International Code Council

A117.1 – 2017 edition

**Public proposals received
On the first public review draft**

Proposal list to the 2017 A117.1 for the 2023 edition

Proposed overlap allowance

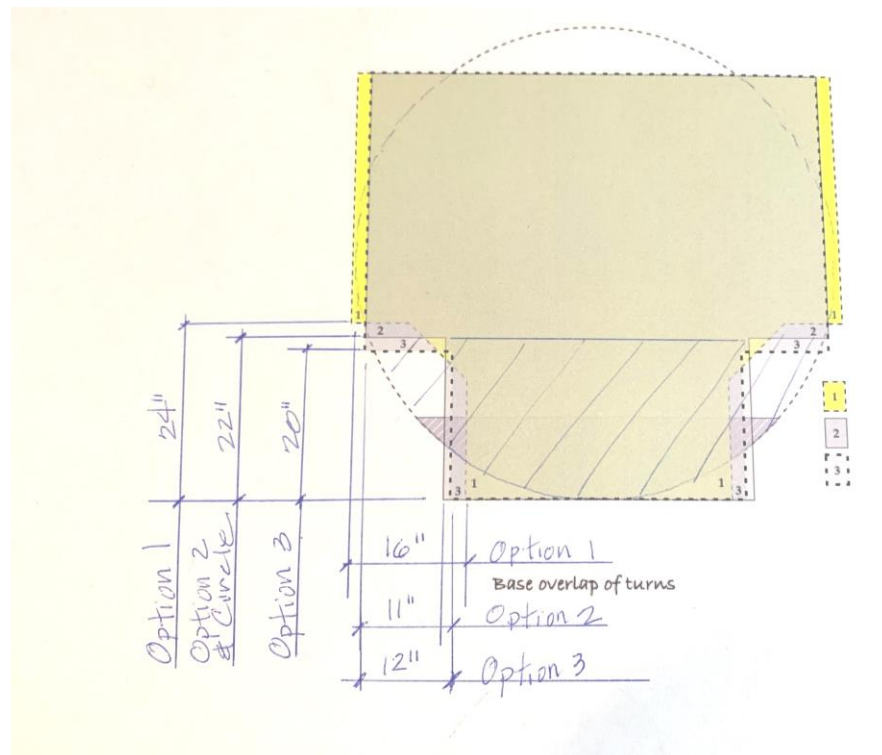
REASON: The purpose of this proposal is to coordinate the overlap allowances for turning spaces. The A117.1 decided not to change the knee and toe clearances between the 2009 and 2017 edition. The turning spaces have increased in size and substantially limited the overlap at the same time. Since the circle and T-turn are to turn 180 degrees, they should be consistent – while now there are substantial differences in all 4 options. With the larger turning space, these proposals will still be a reduction on the total percentage of the turning space permitted under the

FIGURE 406.5.5
CLEAR SPACE AT BOTTOM OF CURB RAMPS AND BLENDED TRANSITIONS

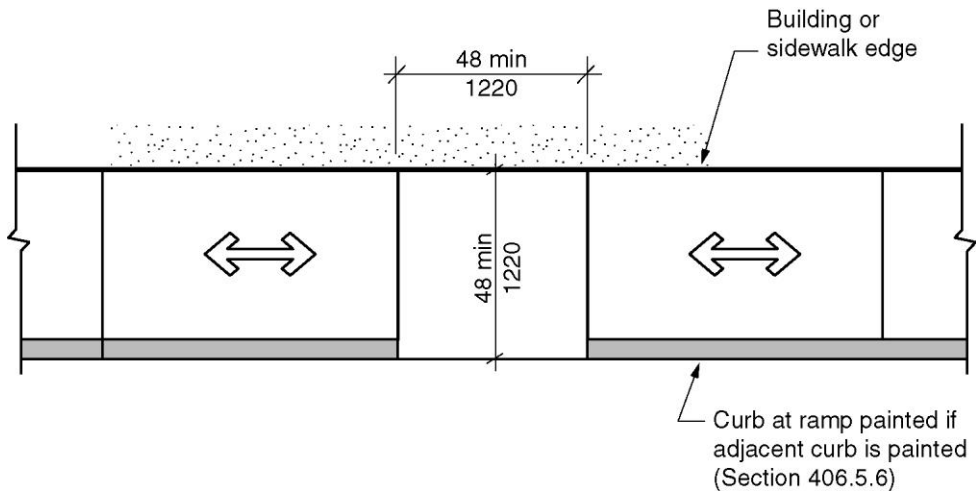
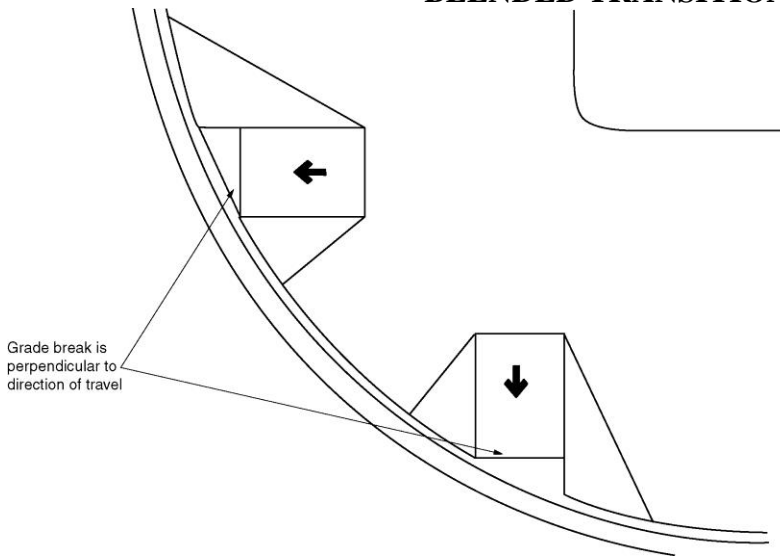
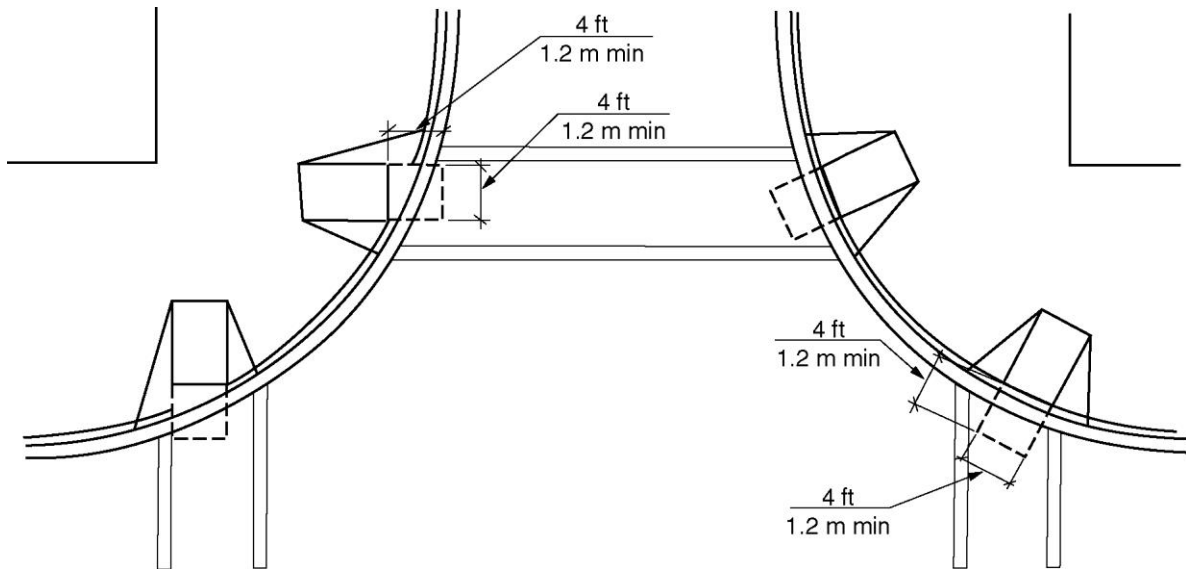
REASON: Curb ramps are not complete without detectable warnings. While there is a section showing detectable warnings on curb ramps in some detail, they should not be omitted here. It implies that they are not required. Wherever curb ramps are depicted, unless they are not required to have detectable warnings, as in Figure 502.9.1, the detectable warning should be included. Figure 502.9.1.2 correctly includes the detectable warning, even though it is in Section 502 Parking Spaces.

**FIGURE 502.9.1
WIDE SIDEWALKS**

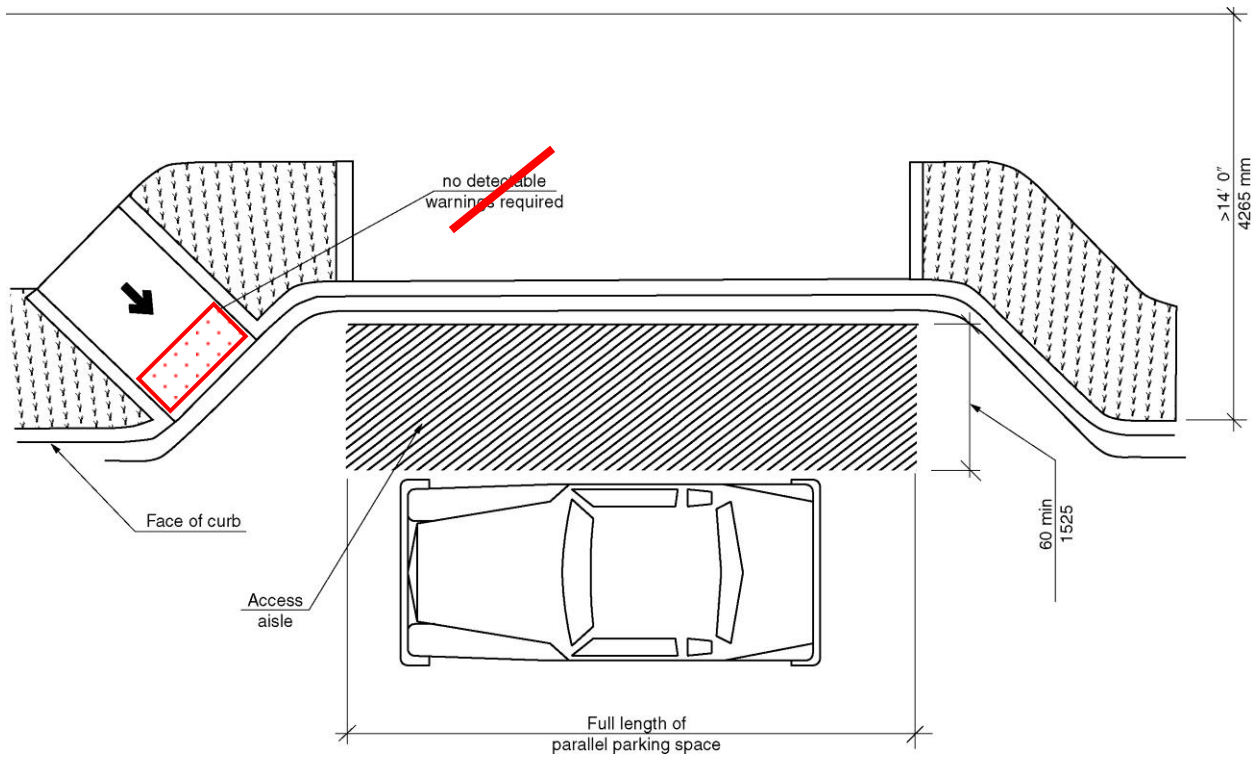
Note: The curb ramp in this figure should show detectable warnings.

REASON: Curb ramps are not complete without detectable warnings. While there is a section showing detectable warnings on curb ramps in some detail, they should not be omitted here. It implies that they are not required. Wherever curb ramps are depicted, unless they are not required to have detectable warnings, as in Figure 502.9.1, the detectable warning should be included. Figure 502.9.1.2 correctly includes the detectable warning, even though it is in Section 502 Parking Spaces.

**FIGURE 503.3(A)
PASSENGER LOADING ZONE ACCESS AISLE - NEW BUILDINGS**

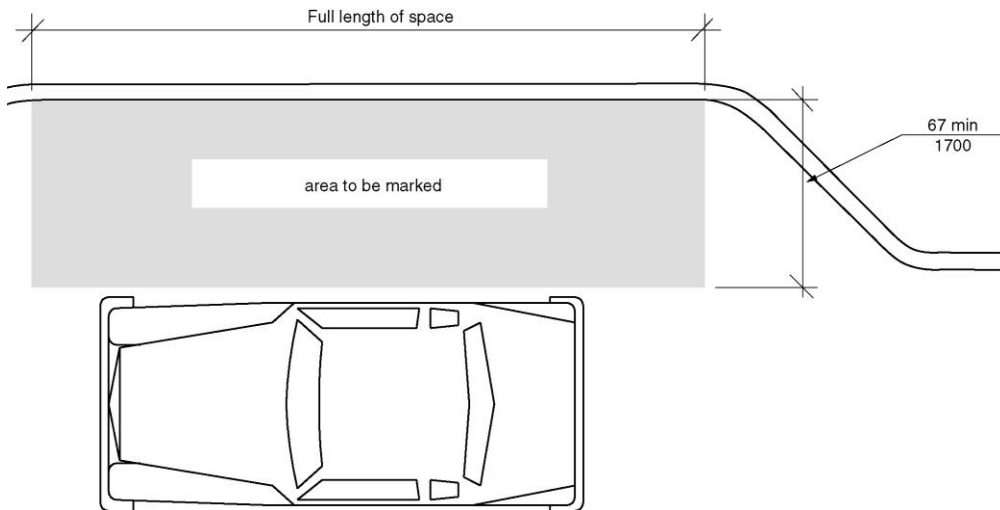
Note: Add curb ramps

Examples of stairway markings in new exception.

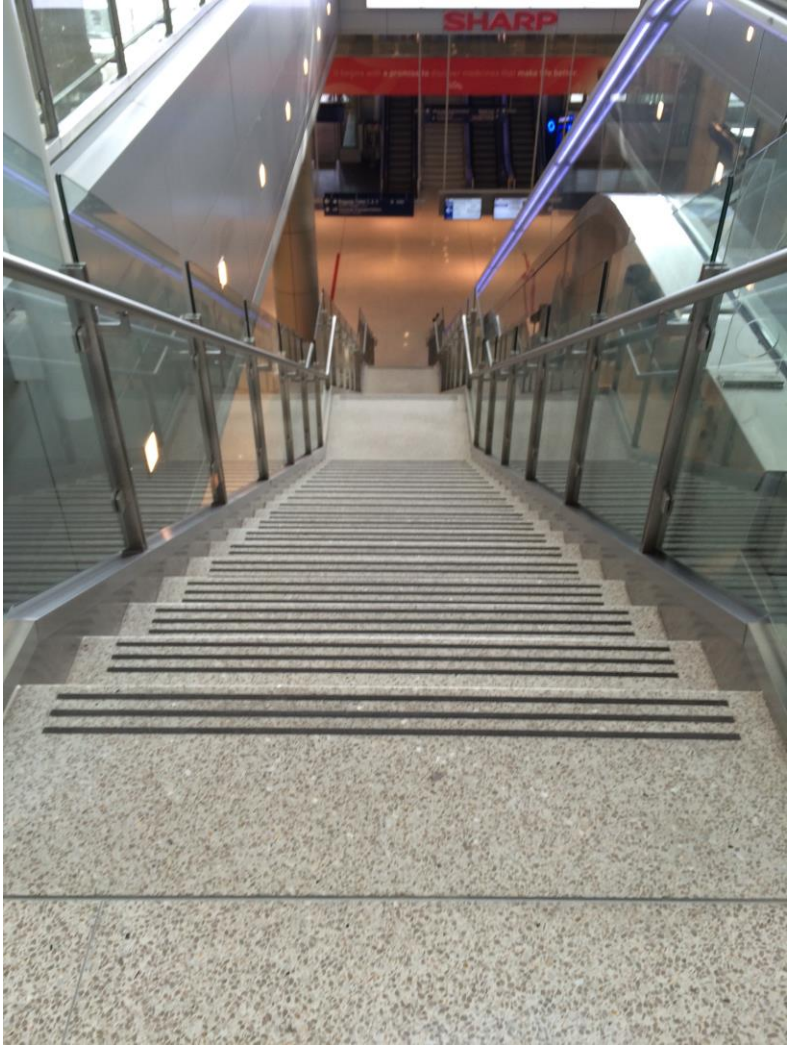
REASON: The intent of this proposal is to provide an alternative for marking stairways. Section 504.6 added an Item 2 to remove the conflict between the A117.1 stairway provisions and where stairways required warning markings are required in IBC. However, not all stairways are required to be marked in IBC. The A117.1 significantly improved the lighting on stairways. This is also in the 2021 IBC Section 1008.2.1. This was recommended as a means to notify visually impaired persons of the change in level to stairways. A stripe at each step is not needed since stairway safety studies indicate muscle memory put as person into a stairway gait in only two steps. See the examples for the new proposed Item 2 and the current Item 1.

Figure 604.9.3(B)
Wheelchair Toilet Compartment Doors
Exception 3 – Alternate Wheelchair Compartment

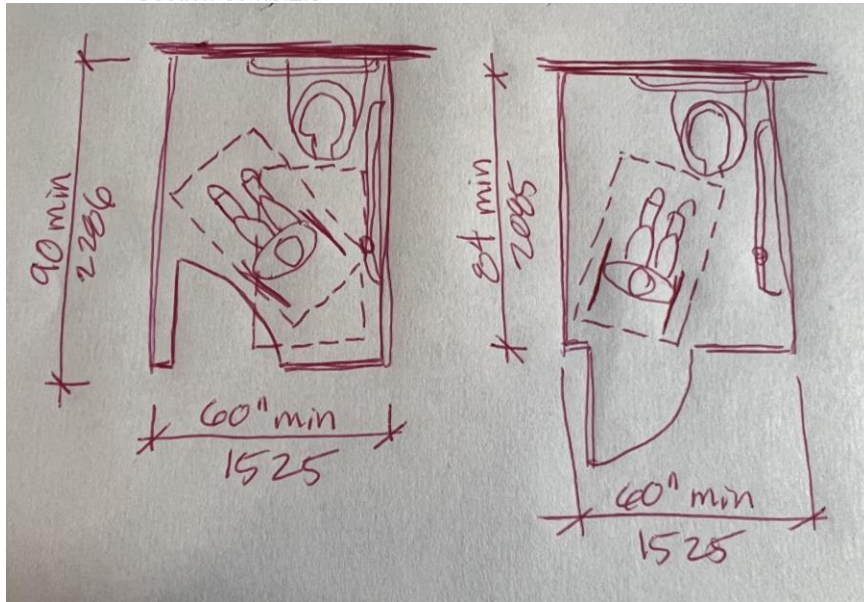
This proposal ties and limits the third exception directly to the alternate compartment provisions of Section 604.9.2.3 and ensures that the door is located to allow a user to move straight into the stall. Without a limitation for the door to be located in the front wall (as was the original intent), Section 604.9.3.1 could be used to allow a side wall door. Again the original proponent and the committee were expecting the door for the “alternate” compartment to be located as shown in Figure 604.9.3(B) and to allow the user to move directly into the compartment and to allow a forward approach to the water closet.

FIGURE 607.5.1

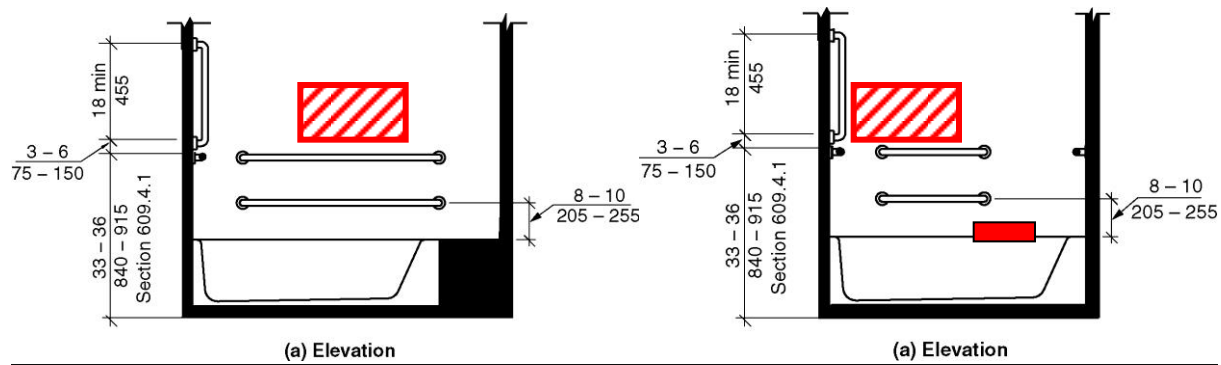
Note: Add two new figures with dimensions to match text for rear wall controls.
